Access Compliance Report

Public Rights-of-Way

(Curb Ramps)

Intersection ID: 49929	Main Street: ASHBOURNE_HALL_RD	Cross Street: CHAMBERLIN_RD	Location: NW
ADA ID: 589EC358E9C0	Ramp Type: Perp	Initial Pass/Fail: Pass	Overall Compliance: No
		Severity Score: 5

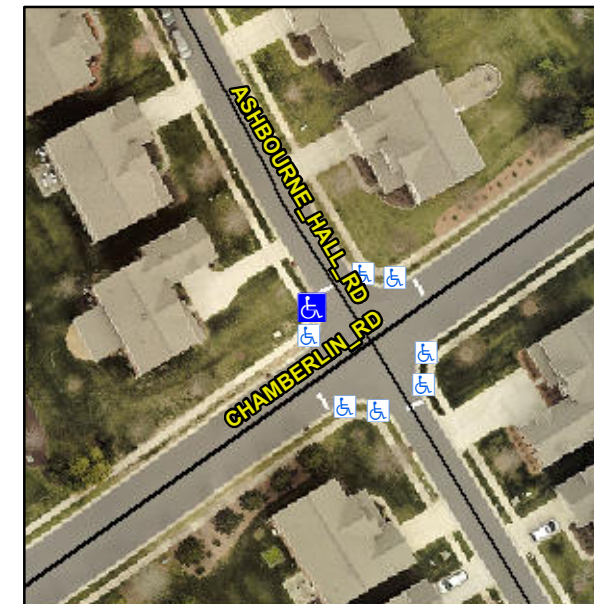
**Not Found, R304.2.1, R304.2.2-Perp,
R304.3.2-Para, R305.2, R304.5.4,
R304.5.3**

Possible Solutions:

**Remove & Replace Entire Ramp.
Remove & Replace Gutter.**
